ADDENDUM No. 1

RFP No. 24-20

Huron River Drive Culvert Replacement

I. CORRECTIONS/ADDITIONS/DELETIONS

INSULATED TRENCH FOR WATER MAIN CONSTRUCTION

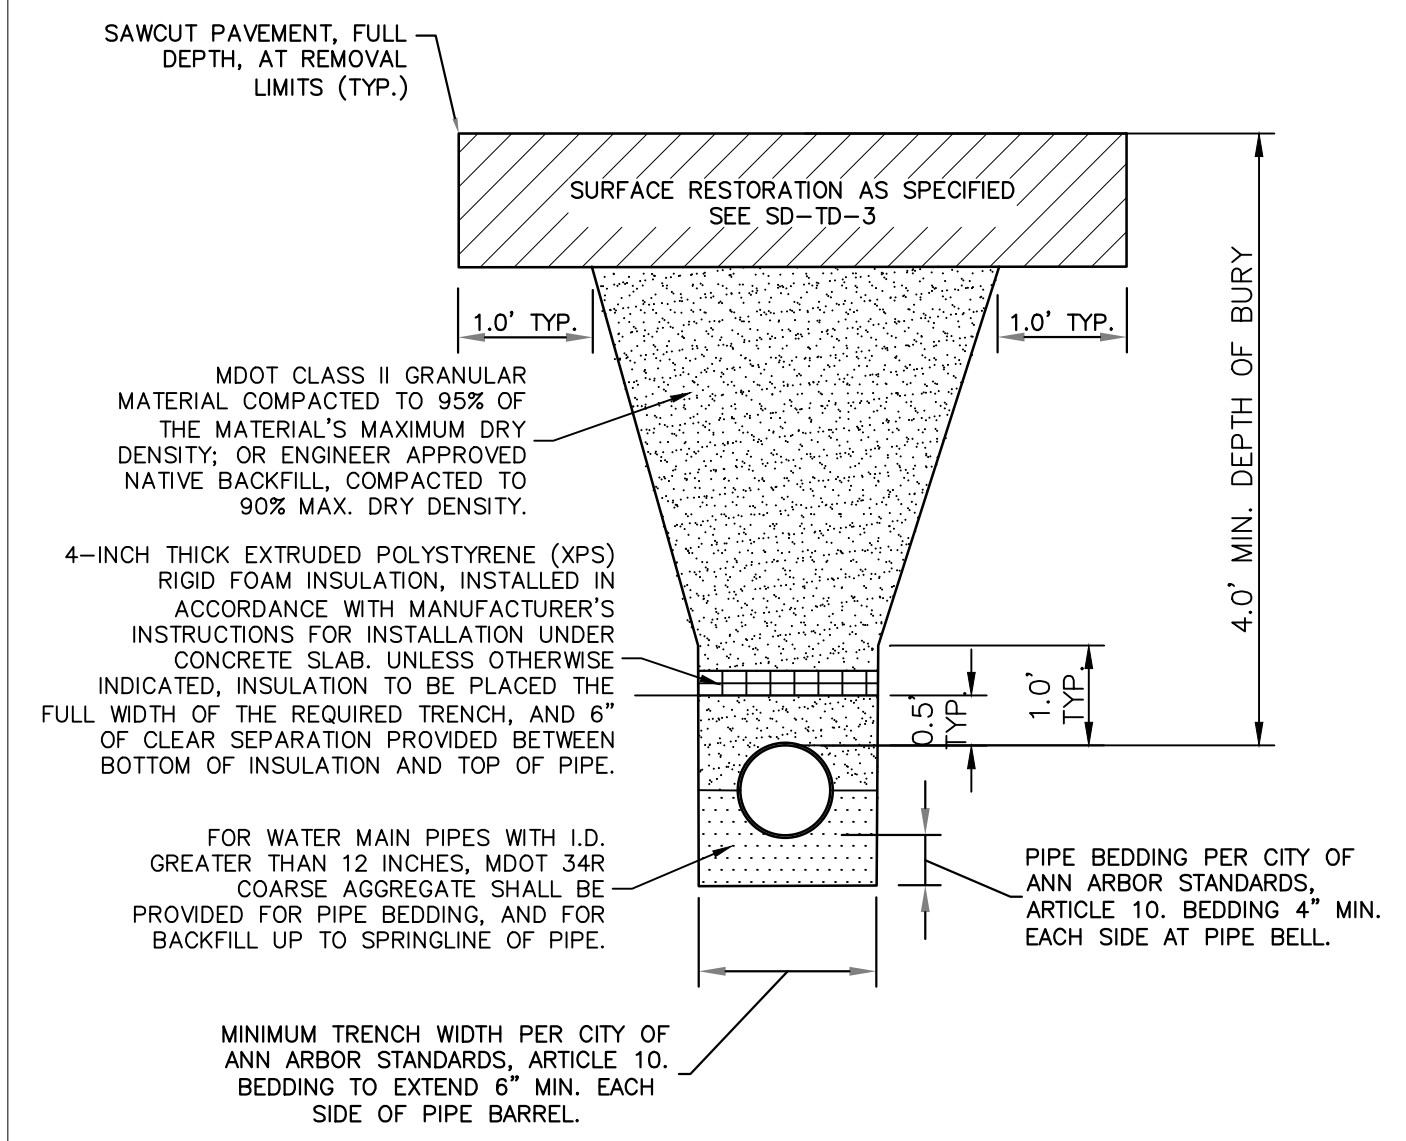
- NOTES:
- WATER MAINS SHALL BE CONSTRUCTED WITH 5-1/2 FEET OF EARTH COVER (ART 3 SEC B.5.9 OF ANN ARBOR STANDARDS). WHERE CONFLICTS EXIST DURING CONSTRUCTION THAT PREVENT THIS COVER REQUIREMENT, THE WATER MAIN MAY BE INSTALLED IN ACCORDANCE WITH THE REQUIREMENTS OF THIS DETAIL. THE CONTRACTOR MUST RECEIVE PERMISSION FROM THE OWNER FOR ANY AND ALL INSTANCES WHERE THIS DETAIL IS PROPOSED TO BE USED.
 - ALL TRENCHING TO CONFORM TO ALL APPLICABLE M.I.O.S.H.A AND CITY STANDARDS.
 - IN AREAS WHERE ROAD PAVEMENT IS SCHEDULED FOR FULL REMOVAL AND REPLACEMENT, THE SIDES OF THE TRENCH SHALL BE SLOPED AS SHOWN IN THE TYPICAL ROAD SECTION(S).
 - IN AREAS WHERE ONLY THE ROAD PAVEMENT ABOVE THE TRENCH IS SCHEDULED FOR REMOVAL AND REPLACEMENT, THE SIDES OF THE TRENCH SHALL BE SLOPED AS SHOWN IN SD-TD-1.

DRAWING No. 2023-008-7

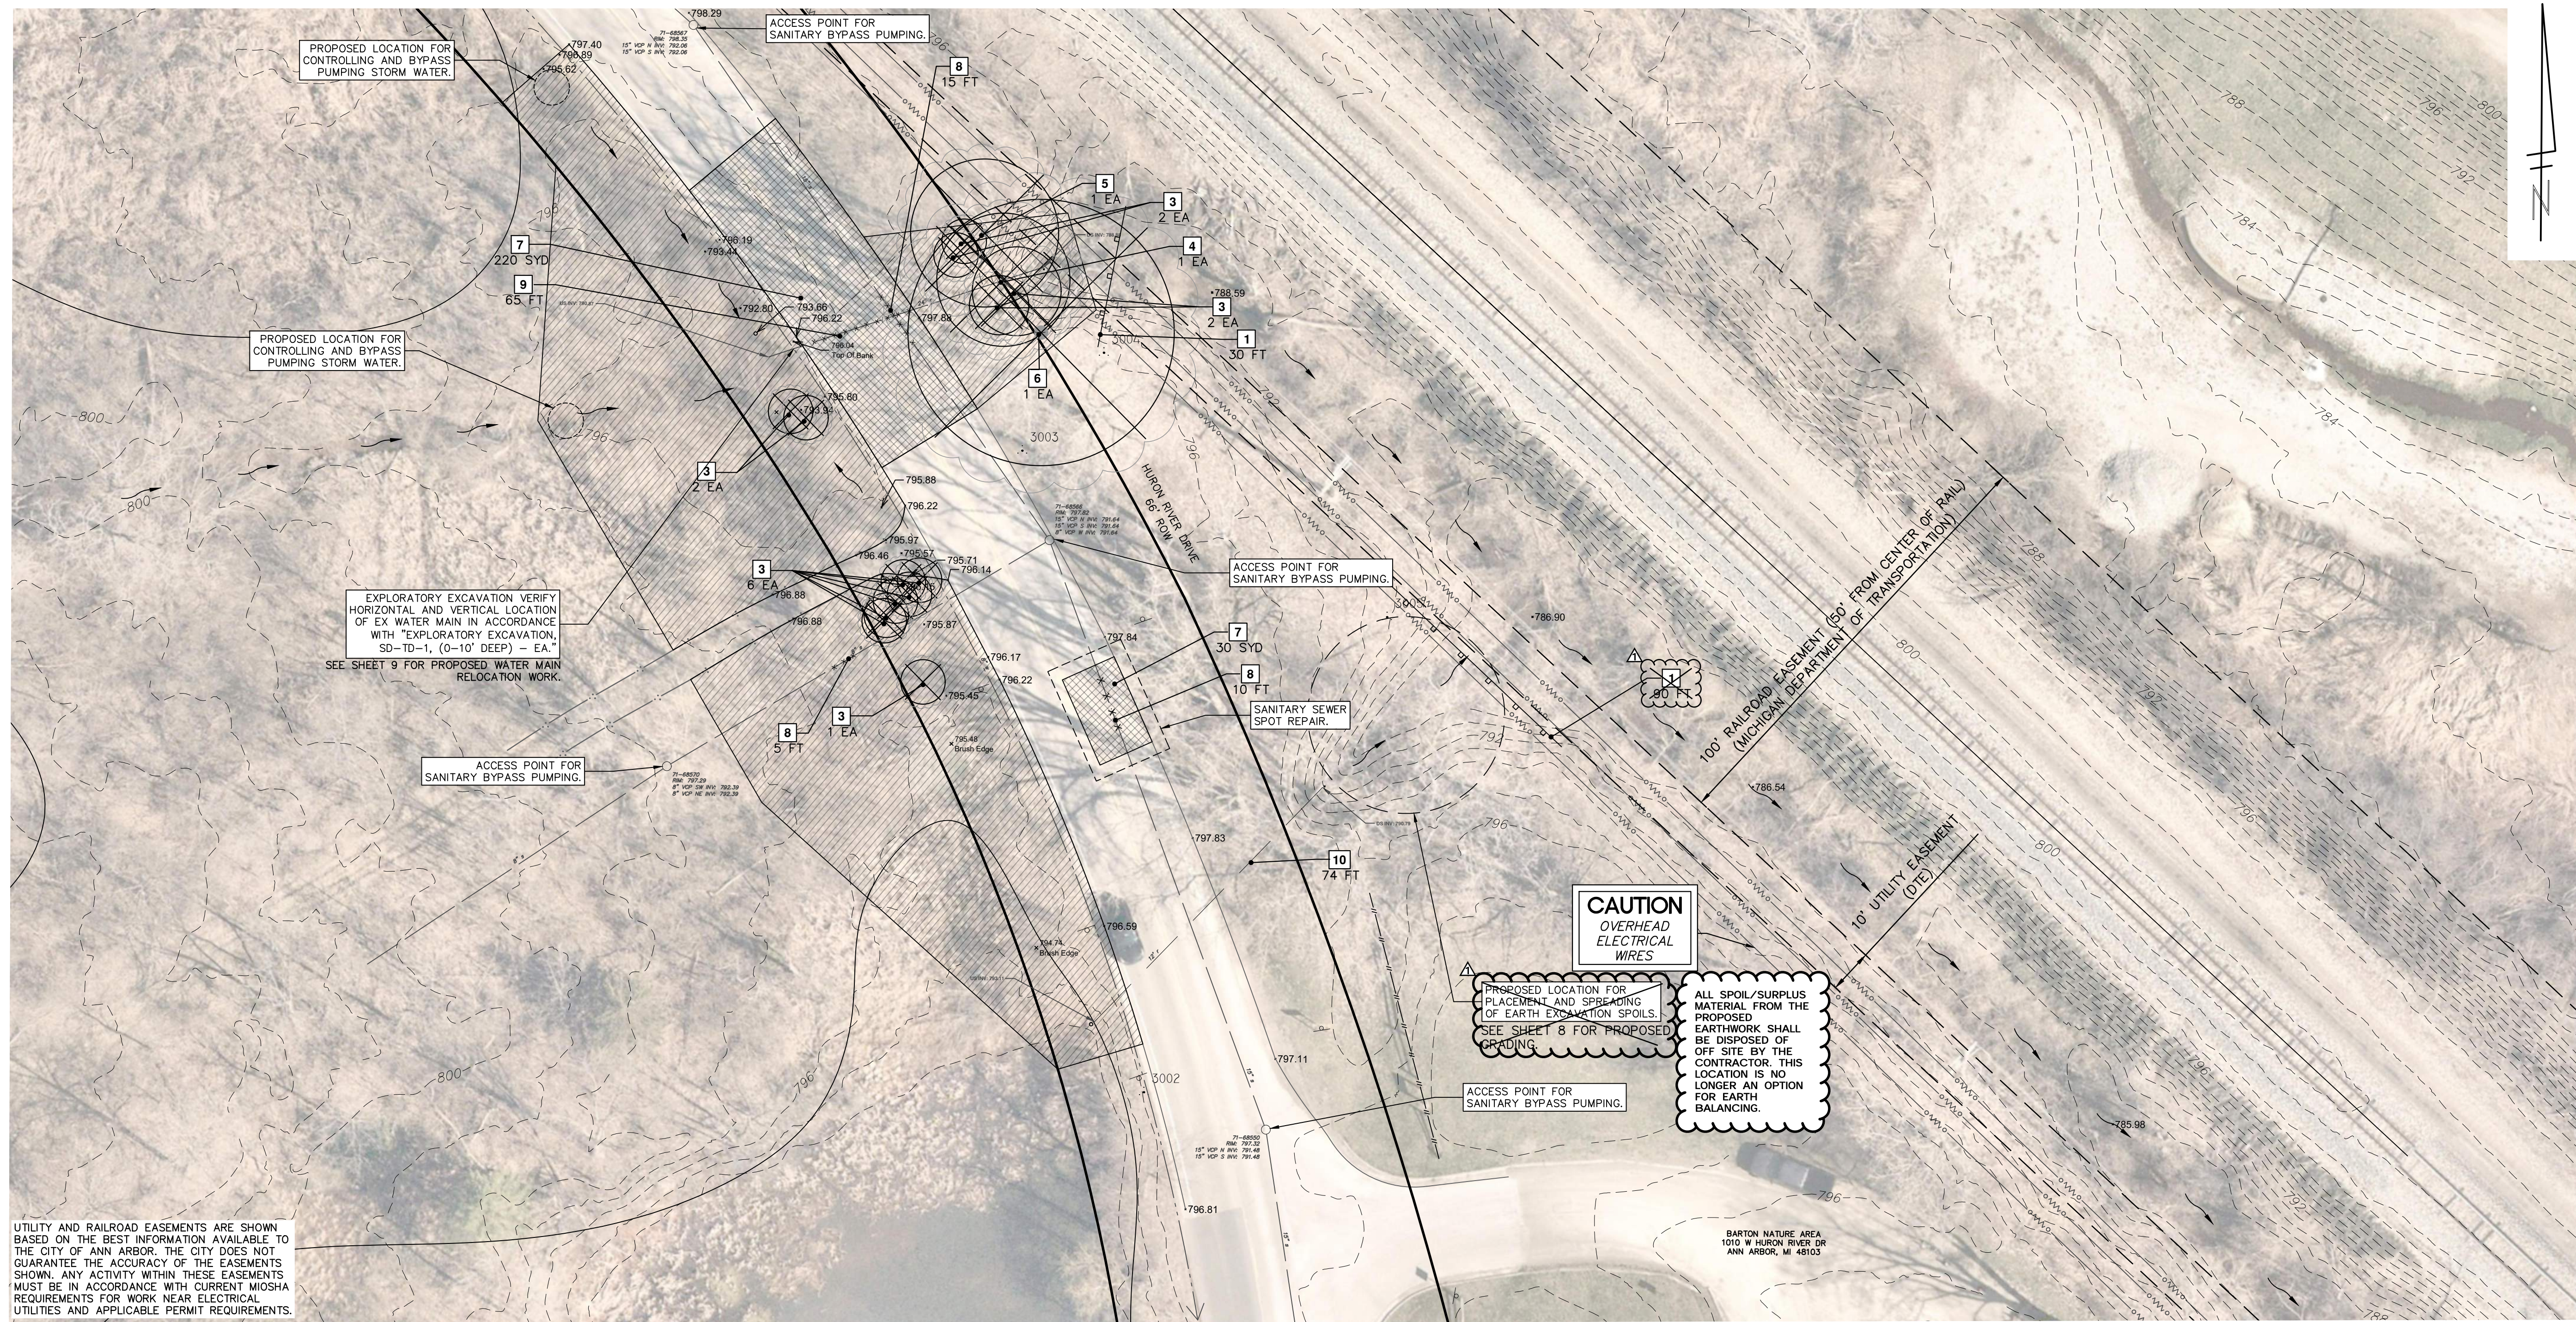
PROPOSED LOCATION FOR PLACEMENT AND SPREADING OF EARTH EXCAVATION SPOILS. SEE SHEET 8 FOR PROPOSED GRADING.

ALL SPOIL/SURPLUS MATERIAL FROM THE PROPOSED EARTHWORK SHALL BE DISPOSED OF OFF SITE BY THE CONTRACTOR. THIS LOCATION IS NO LONGER AN OPTION FOR EARTH BALANCING.

CONSTRUCTION

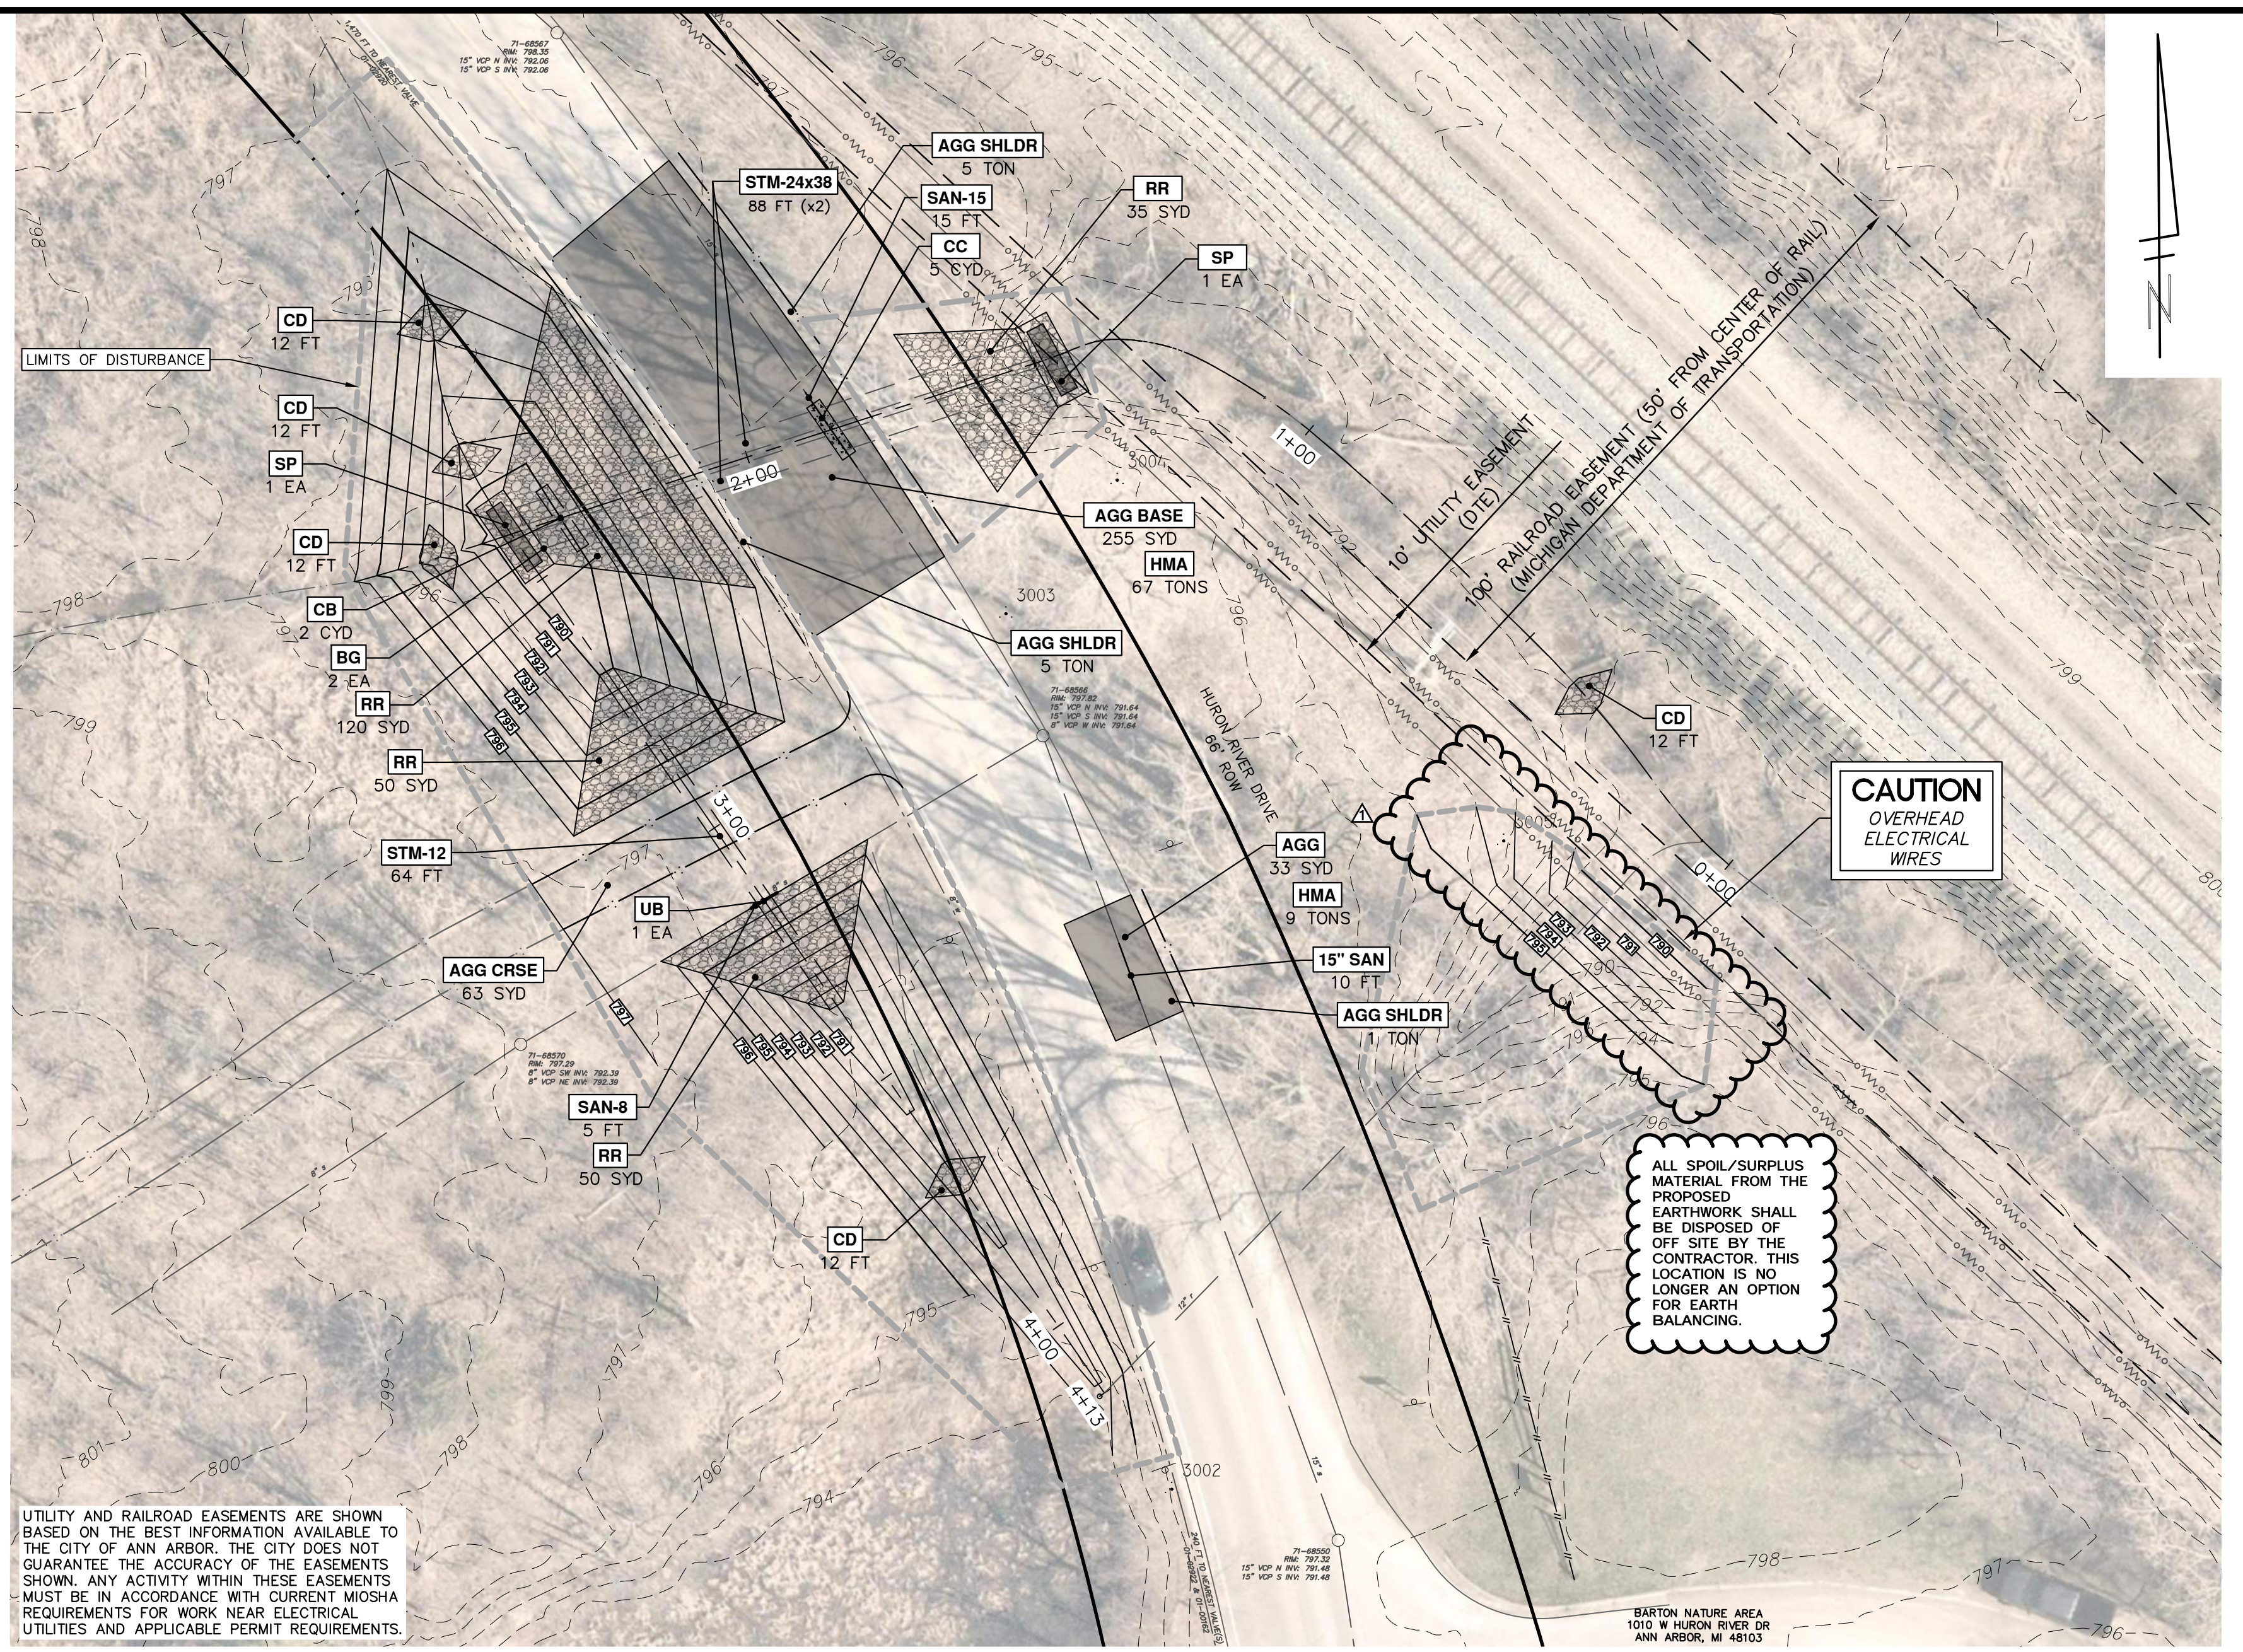
- NOTES:**
1. PLACEMENT AND SPREADING OF EARTH EXCAVATION SOILS AT THE OUTLET END OF THE CULVERT SHALL BE ABANDONED IS NOT PERMITTED UNTIL A NEW OUTLET IS PROVIDED.
 2. THE TRANSPORTATION AND OFF-SITE DISPOSAL OF ANY AND ALL SURPLUS EARTH EXCAVATION SPOILS SHALL BE CONSIDERED INCIDENTAL TO THE UNIT PRICE BID FOR THE ITEM "EARTH EXCAVATION - CYD" AND WILL NOT BE PAID FOR SEPARATELY.
 3. PLACEMENT AND GRADING OF EARTH EXCAVATION SOILS AT THE LOCATIONS AND TO THE LIMITS AND GRADES INDICATED SHALL BE PAID FOR AS "DS MACHINE GRADING - SYD."

ALL SPOIL/SURPLUS MATERIAL FROM THE PROPOSED EARTHWORK SHALL BE DISPOSED OF OFF SITE BY THE CONTRACTOR. THIS LOCATION IS NO LONGER AN OPTION FOR EARTH BALANCING.
